Model 114 Service Letter Index (Cont)

SERVICE LETTER NO. SL-114-1A

CABIN NOISE REDUCTION

Figure 3
New Fuel Flow Totalizer Transducer Installation

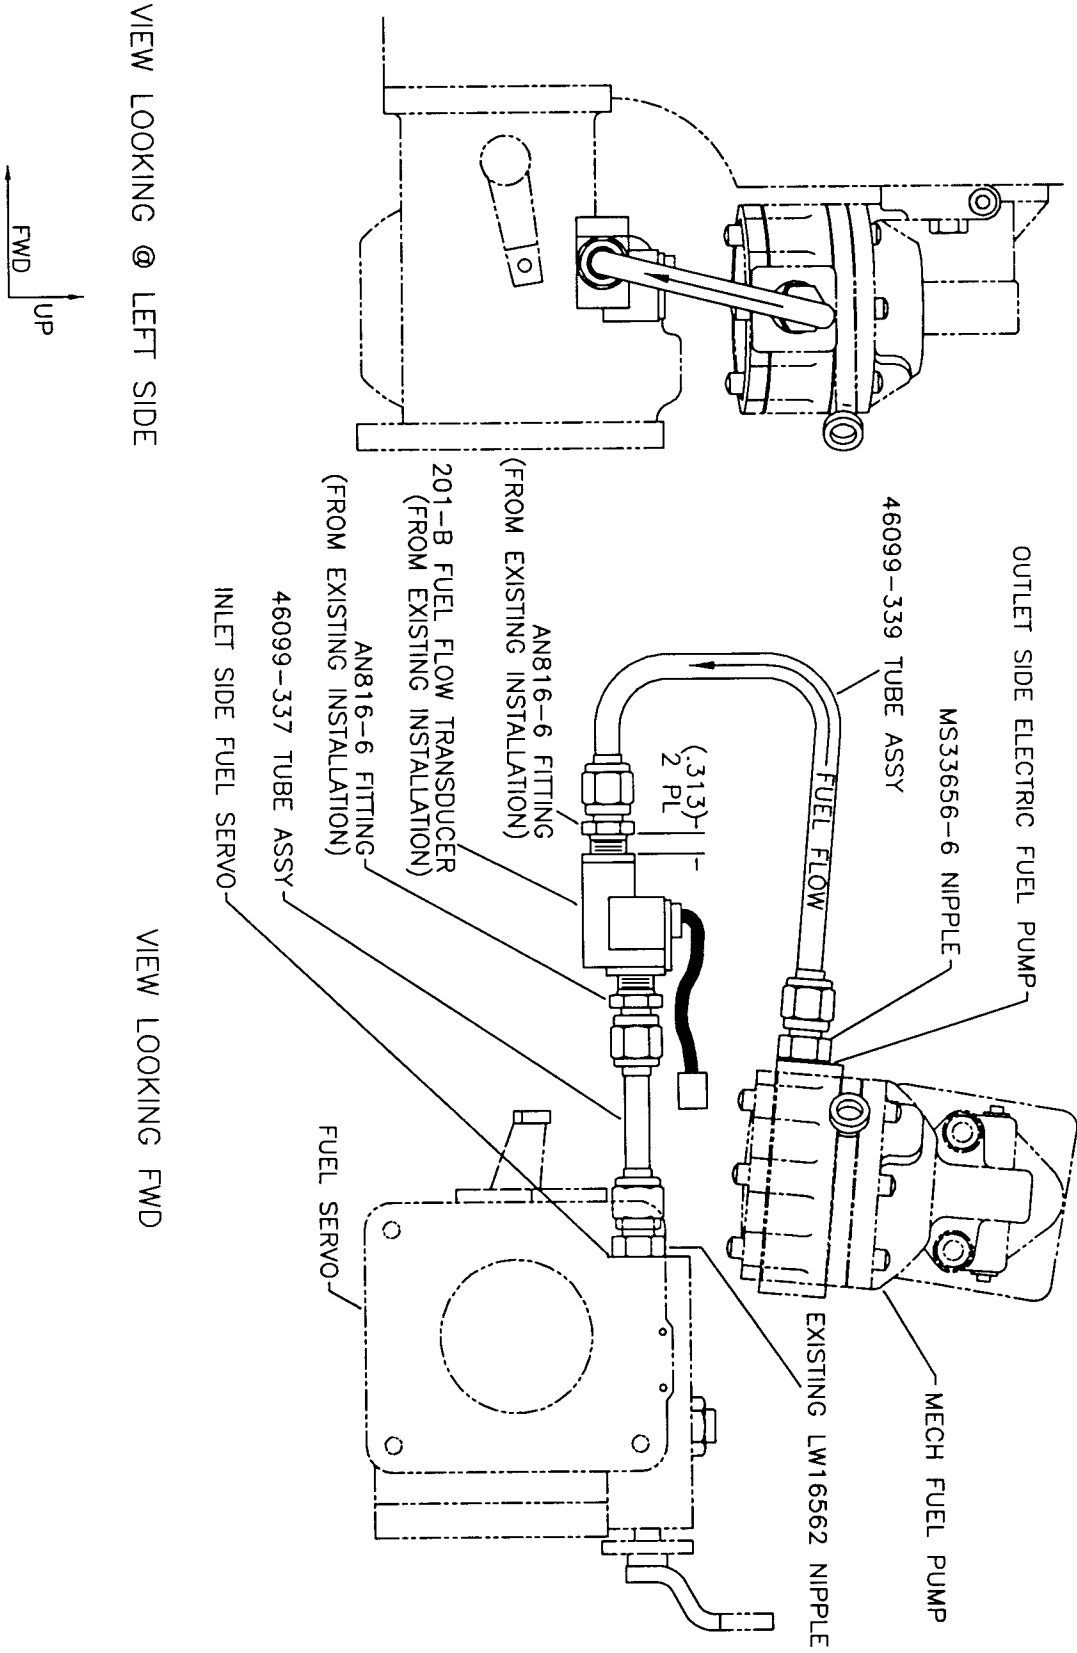
1. Attach the MS33656-6 Nipple to the outlet side of the **Engine Driven** Fuel Pump.
2. Attach the short end of the 46099-339 Tube Assembly to the inlet side of the Fuel Flow Transducer (See Figure 3).
3. Attach one end of the 46099-337 Tube Assembly to the outlet side of the Fuel Flow Transducer (See Figure 3).
4. Attach the long end of the 46099-339 Tube Assembly to the MS33656-6 Nipple attached to the outlet side of the **Engine Driven** Fuel Pump (See Figure 3).
5. Attach the other end of the 46099-337 Tube Assembly to the existing LW16562 Nipple attached to the inlet side of the Fuel Servo (See Figure 3).

Figure 1

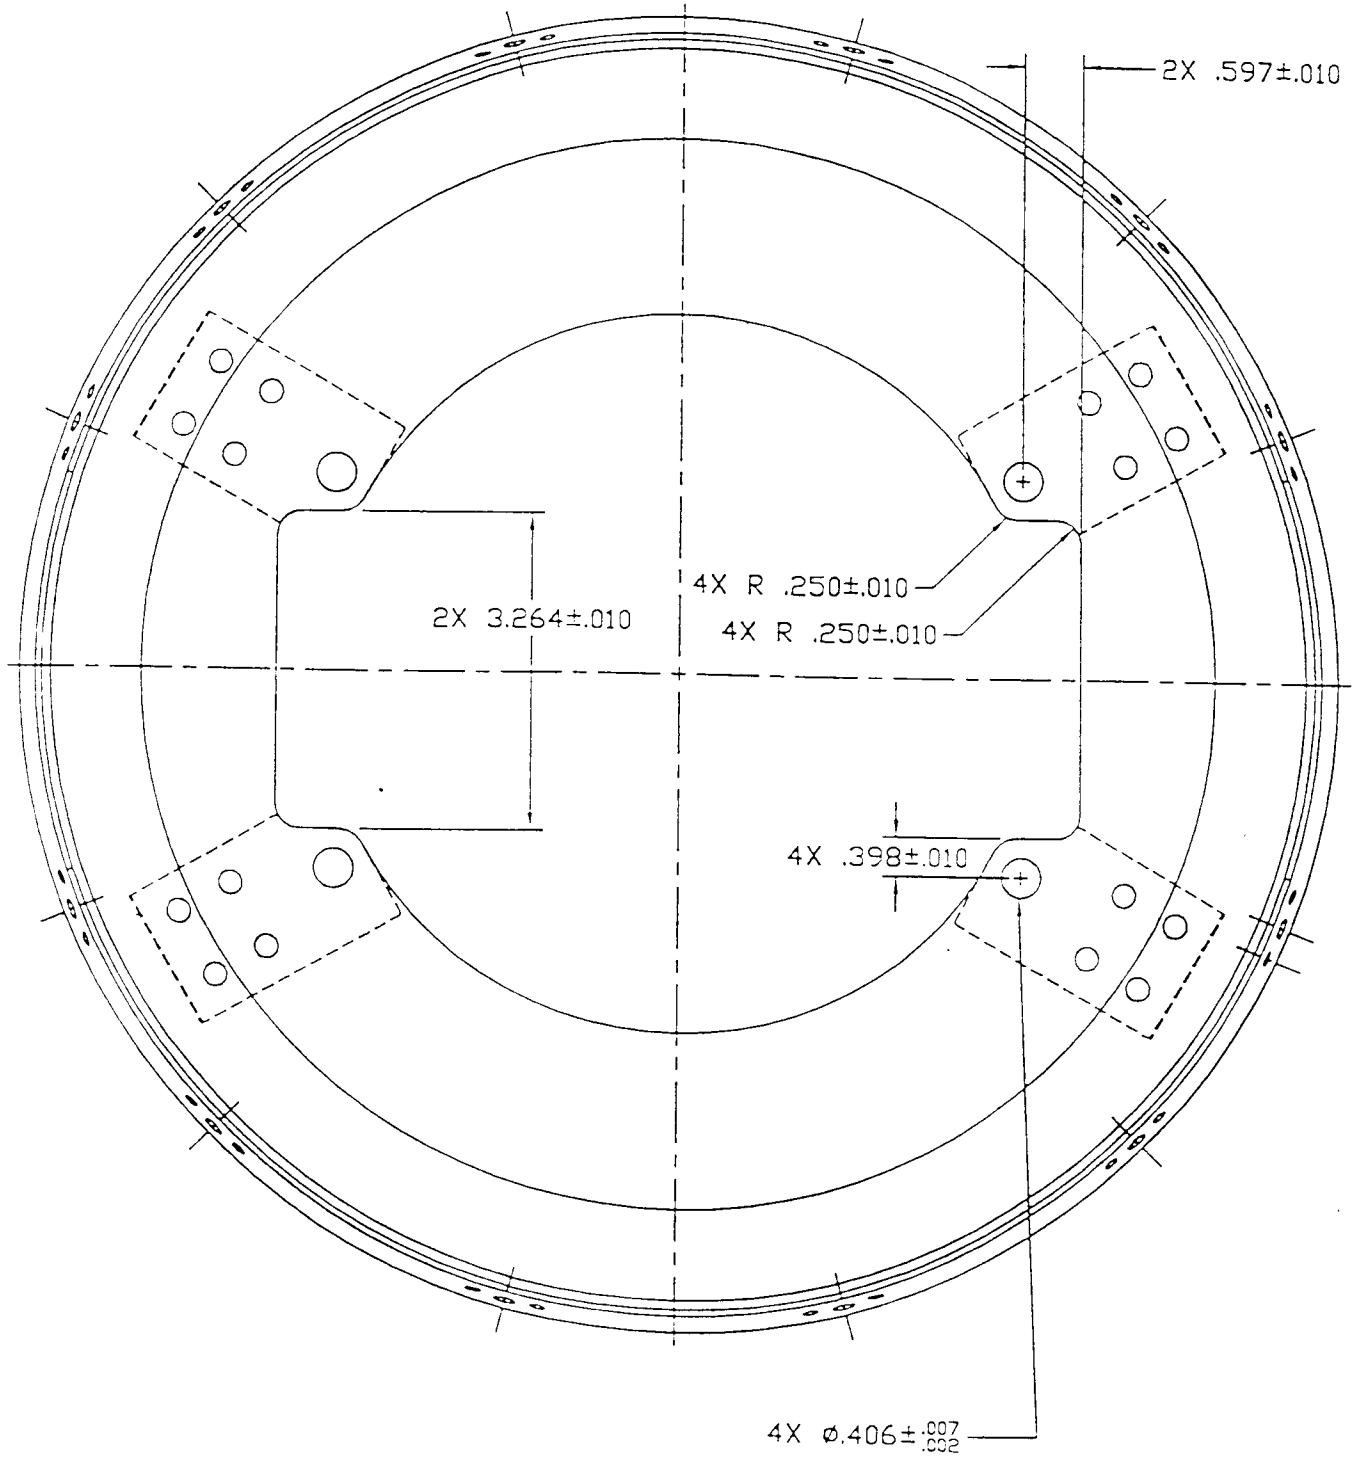
- (a) Remove material from bulkhead to provide clearance for new style hub.
Make cutouts in accordance with the dimensions given in figure 1.
- 1 Fabricate a template to match the broken lines in figure 2.
